M^CLAREN TRAFFIC ENGINEERING

25 June 2026

Reference: 250737.03FA

LETTER OF RESPONSE TO DPHI, TWEED SHIRE COUNCIL AND TFNSW REGARDING THE PROPOSED MIXED USE DEVELOPMENT AT 4-8 BELLS BOULEVARD, KINGSCLIFF

8.3m Waste Vehicle Entry / Exit from Loading Dock
2 Manoeuvres REVERSE ENTRY / 1 Manoeuvre FORWARD EXIT
Successful

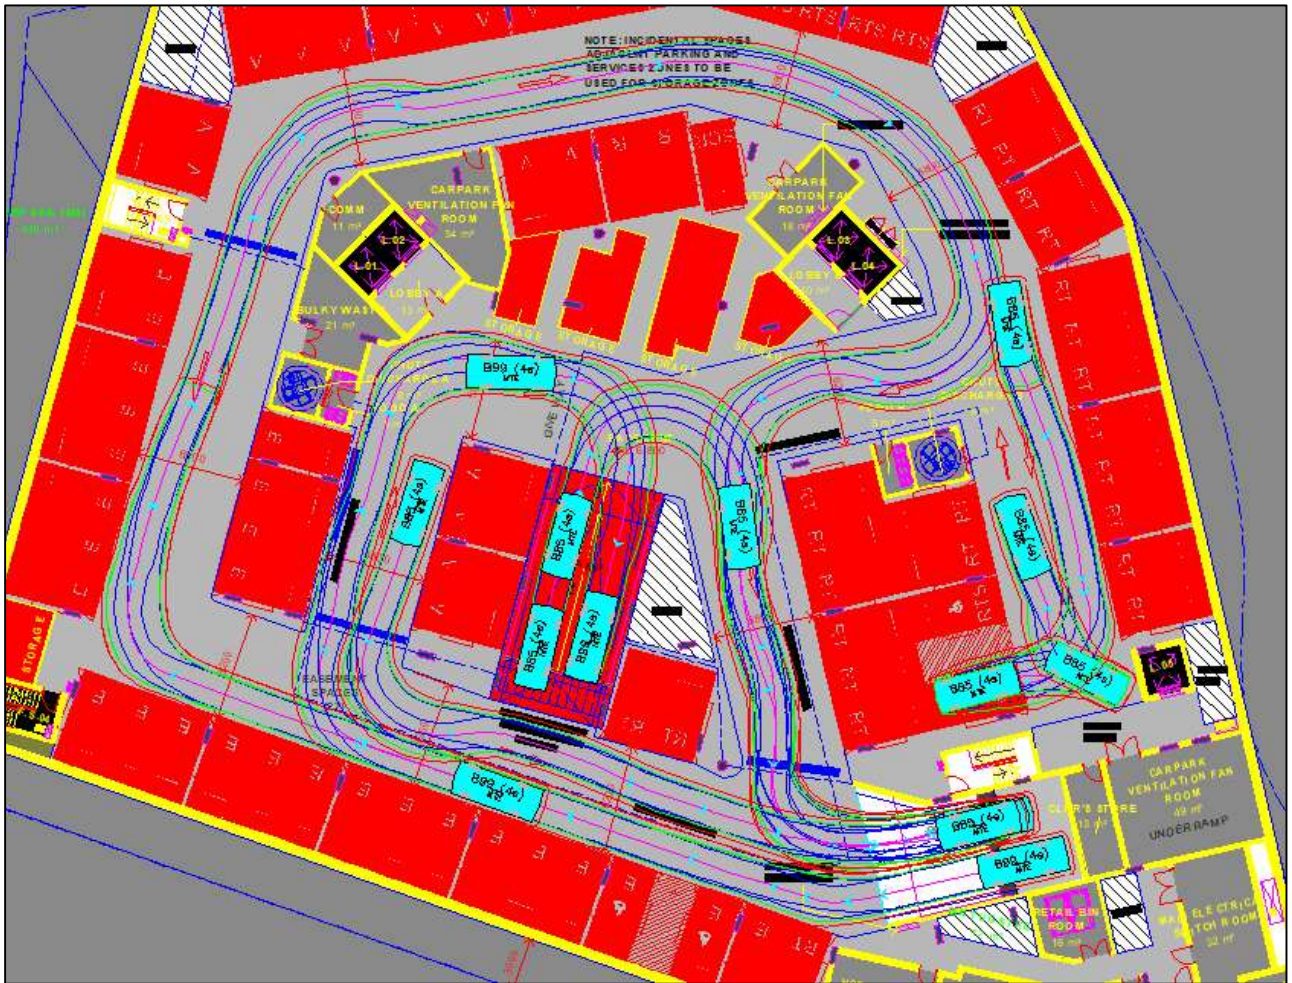
The size of the loading bay has been designed for a custom collection vehicle. The size of the vehicle and the loading bay raises concerns with the vehicle being able to leave in a forward direction. The loading bay provides minimal flexibility for the MRV to be able to manoeuvre, and the loading bay is at flat slope adjacent to a sloping vehicle access ramp. The change in slope and levels is considered problematic for the MRV and vehicle access into the loading bay should be re-considered.

MTE Response: Swept path testing of the custom waste collection vehicle has been completed with the successful results being provided in **Annexure D**. These swept paths demonstrate that the custom waste collection vehicle (less than MRV length) can enter and exit in a forward direction, as per the requirements of an occasional service definition in AS2890.2:2018.
